**OHIO TURNPIKE AND
INFRASTRUCTURE COMMISSION**

ADDENDUM NO. 1

PROJECT NO. 59-20-01
REPAIRS AND RESURFACING
EASTBOUND AND WESTBOUND ROADWAYS
MILEPOST 80.50 TO MILEPOST 90.02
OTTAWA & SANDUSKY COUNTIES, OHIO

Plan Sheet: 5 and 7 of 14

DESIGN AGENCY	BY DATE	REVISIONS	NO.	DATE
	JJS 12/18/18			
		ADDENDUM NO. 1		
DESIGNED	CHECKED	IN CHARGE	ADY	
JJS	JJS	JJS		
DRAWN	CAM			
JJS	ADY			
TYPICAL SECTIONS ASPHALT OVERLAY SECTIONS				
PROJECT 59-20-01				
5 14

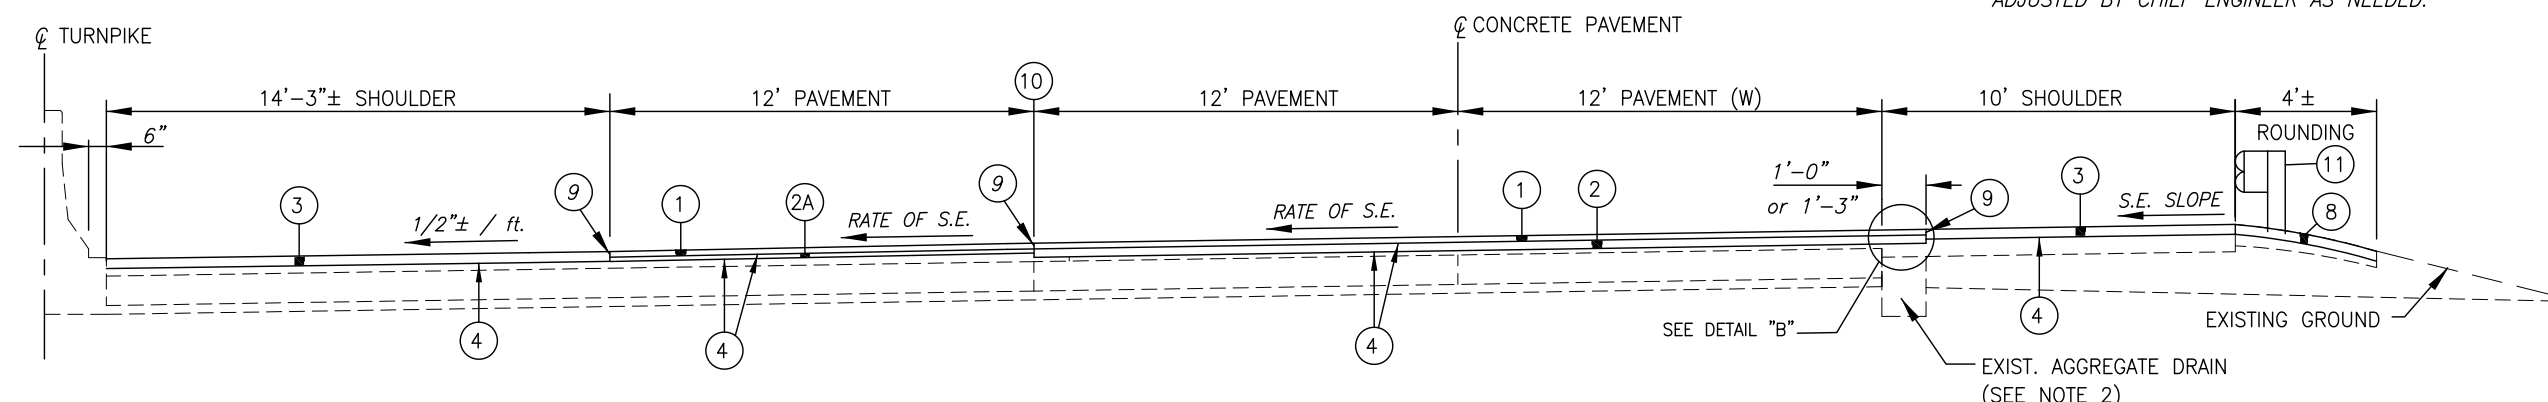
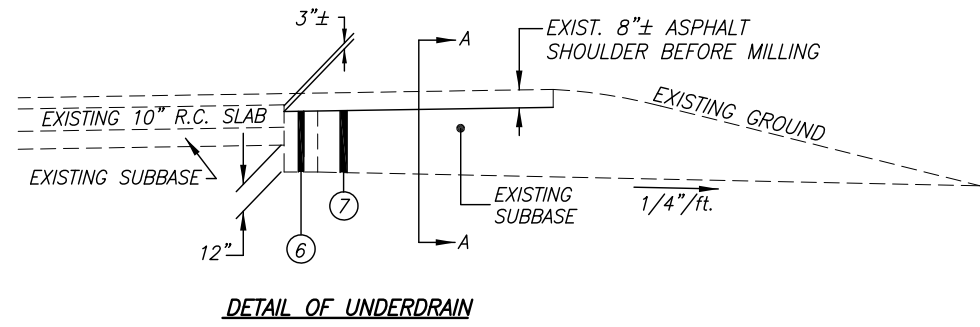
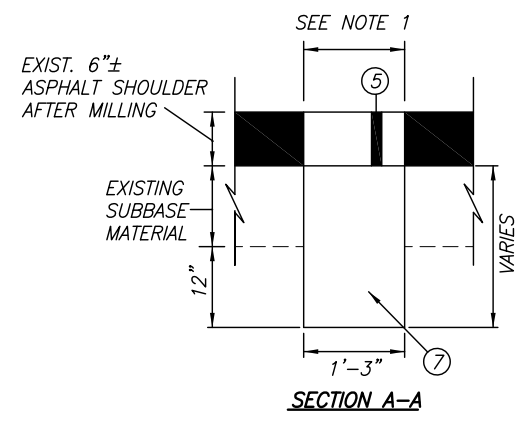
Q#6 On sheet 5/14, does note #5 apply for this project?

A#6 *Plan Sheet 5 of 14 has been reviewed and revised. Plan Note #5 has been removed. Revised Plan Sheet 5 of 14 has been included with this Addendum No. 1.*

REINFORCED CONCRETE APPROACH SLAB

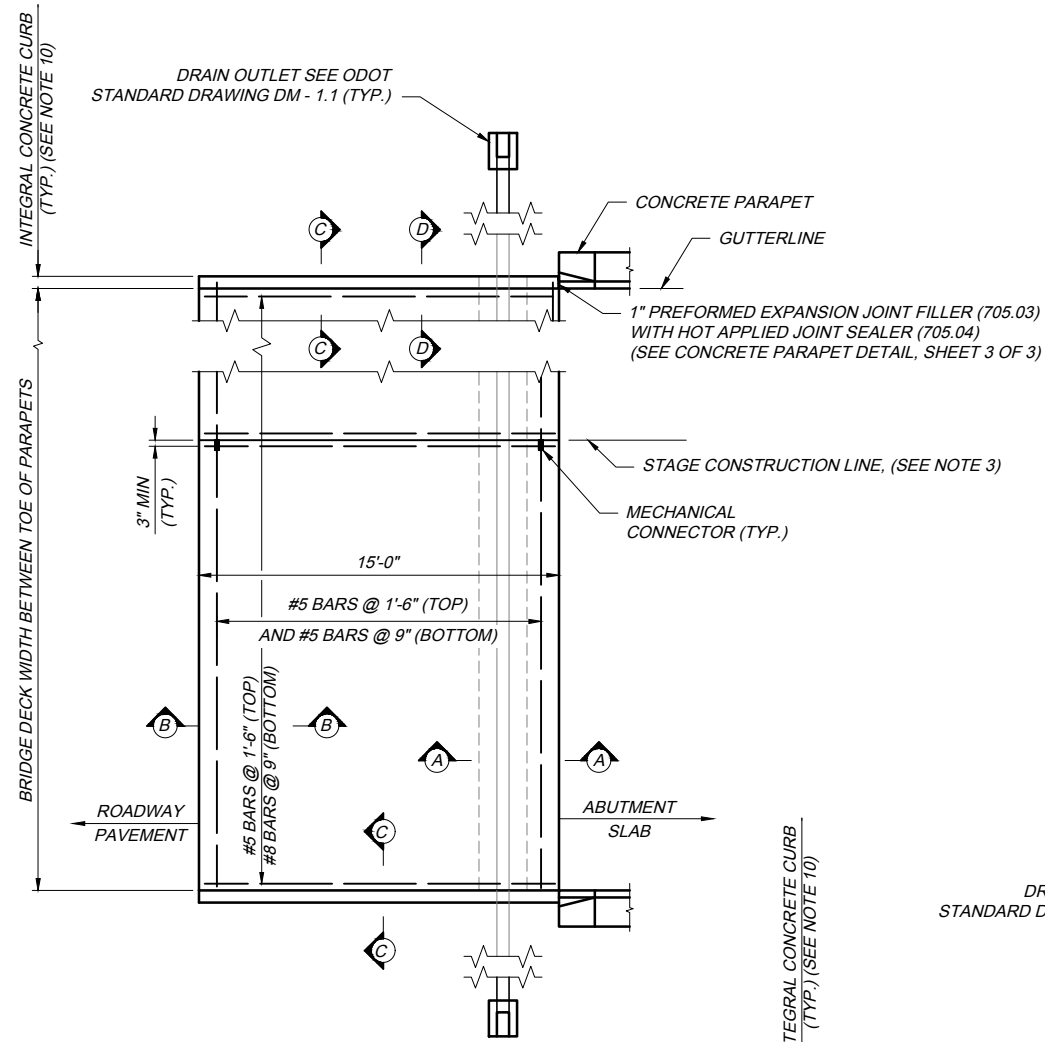
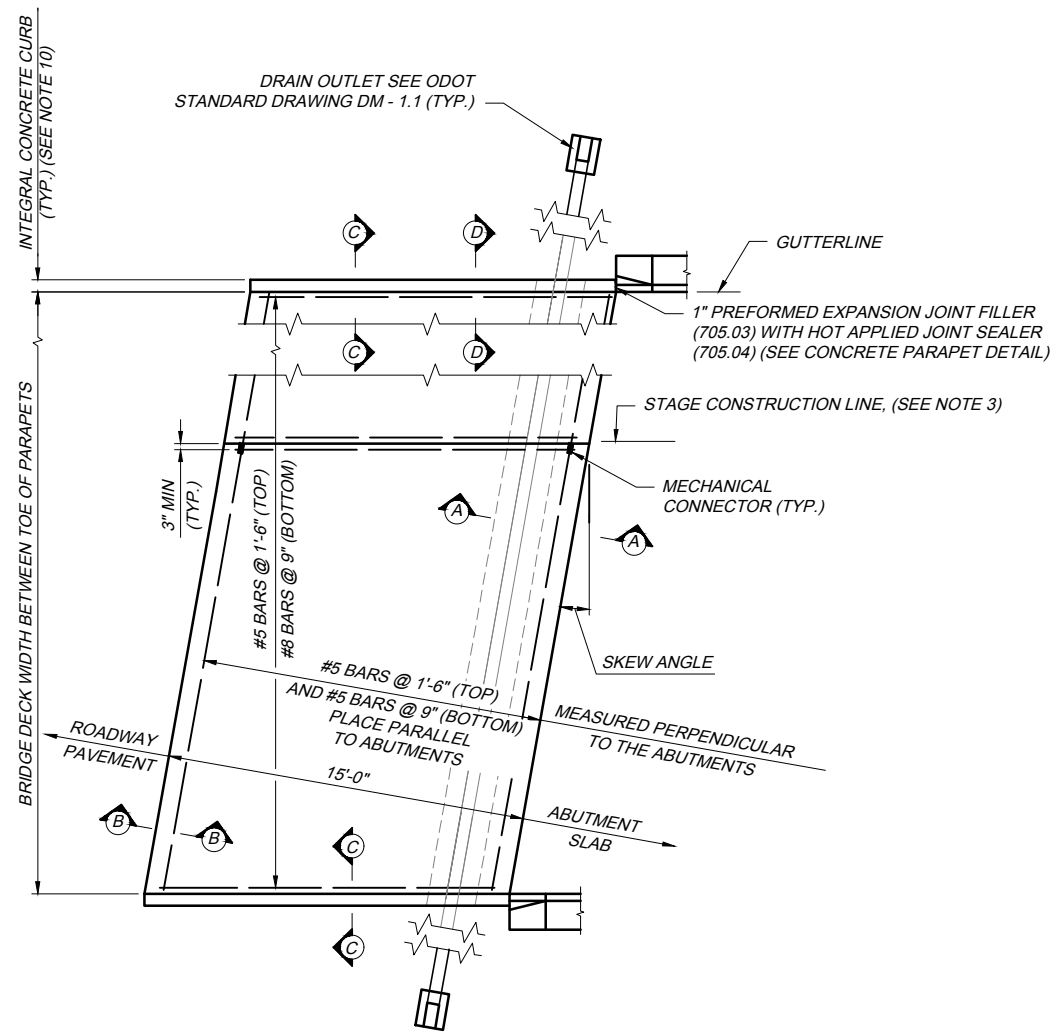
- Q#2 Bid Ref #26 – Reinforced Concrete Approach slabs (T=12”) app, the note (1) on sheet 3/14 says Approach slab removal and replacement performed during a work shift shall be completed during that same work shift. No repair shall be left open beyond end of the shift. Also, note #4 add a contingency quantity to patch concrete structures to repair the grade beams. 1) If its determined that the grade beam needs patched after removal of approach slab how is the Contractor supposed to patch the grade beam, allow for cure time for patching and pour new approach slab during the same shift? If the grade beam does need patching and the repair area needs to be left opened what traffic protections will be required?

- A#2 *If it is determined that the grade beam needs to be patched and the patching area is adjacent to a live lane of traffic, the contractor may utilize temporary steel road plate(s) to span the repair area. If the grade beam does not need patching, and the Contractor is not able to stage the Work (Note 2 Plan Sheet 3 of 14) the Contractor may use steel road plates to span the repair area that is adjacent to a live lane of traffic. The cost of providing steel road plates shall be considered incidental to Item SP 614, Maintaining traffic, As Per Plan.*
